marantz® SERVICE BULLETIN		Date: 28-Dec-2004	Model: SR7400/SR7500/SR8500
		Page: 1 / 1	REF.NBR: MZ04-085
Level		Application:	
★ ★		See below	
		Subject: FL Display does not light up.	
		Int.ref:

SR7400

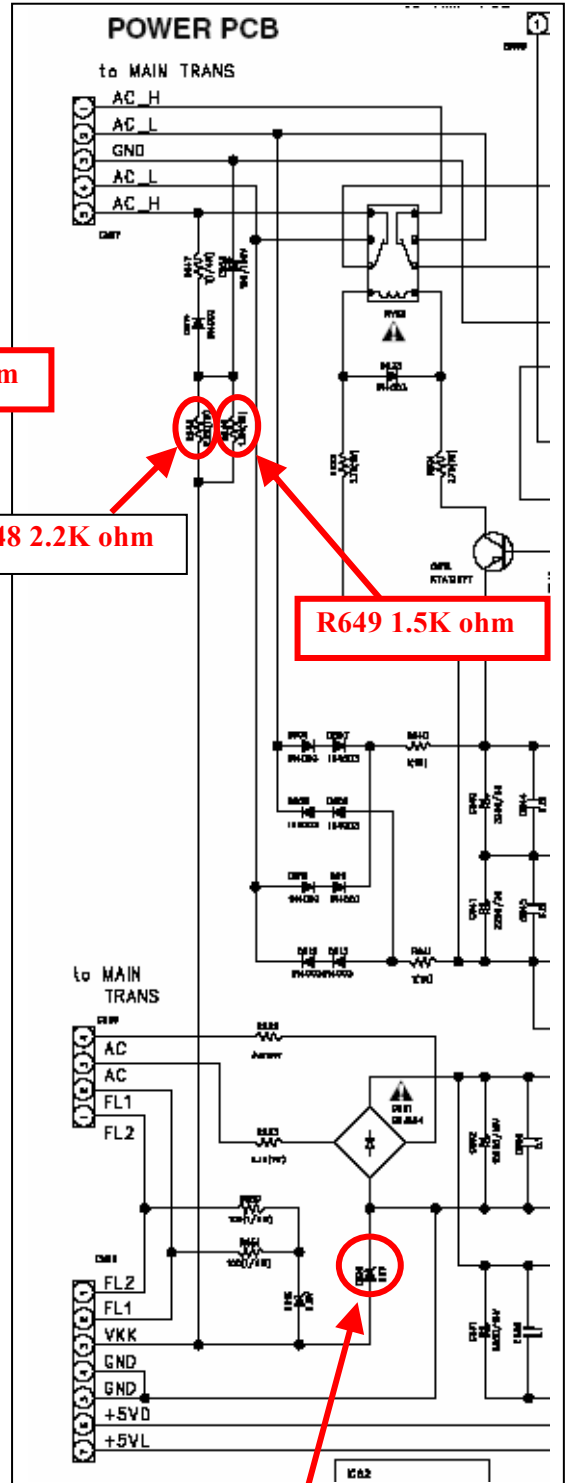
1. In condition, AC input is about 10% overvoltage than Rated voltage and the sound is not outputted for a long time.
2. The DIODE (POS NO.D616) may short-circuit. R648 and R649 are broken by this short-circuit.

D616 Zener Diode part no. 90M-HD302190R

1. POS.NO **R649** RESISTOR (**1.5K OHM**) is changed to RESISTOR(**2.2K OHM**) on the POWER PCB

POS.NO. R649 nsp (RESISTOR 2.2K OHM 1WJ) Factory code number KRG1SANJ222RT

SR7500 / SR8500

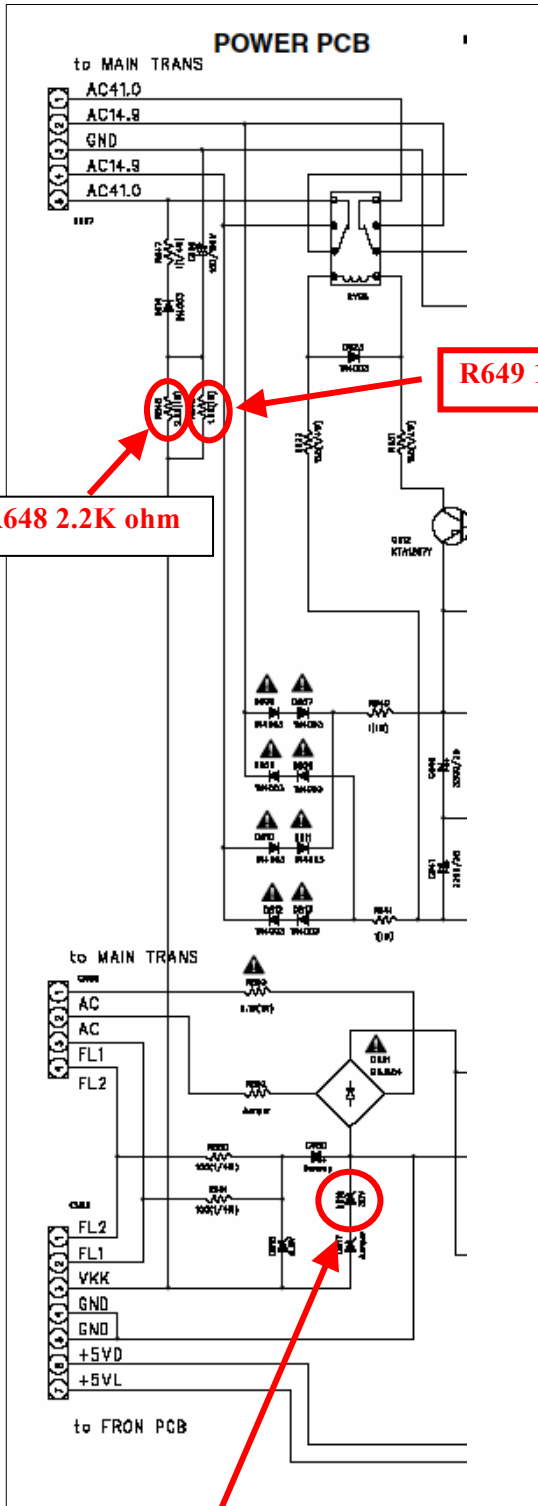
D616 Zener Diode part no. 90M-HD302190R
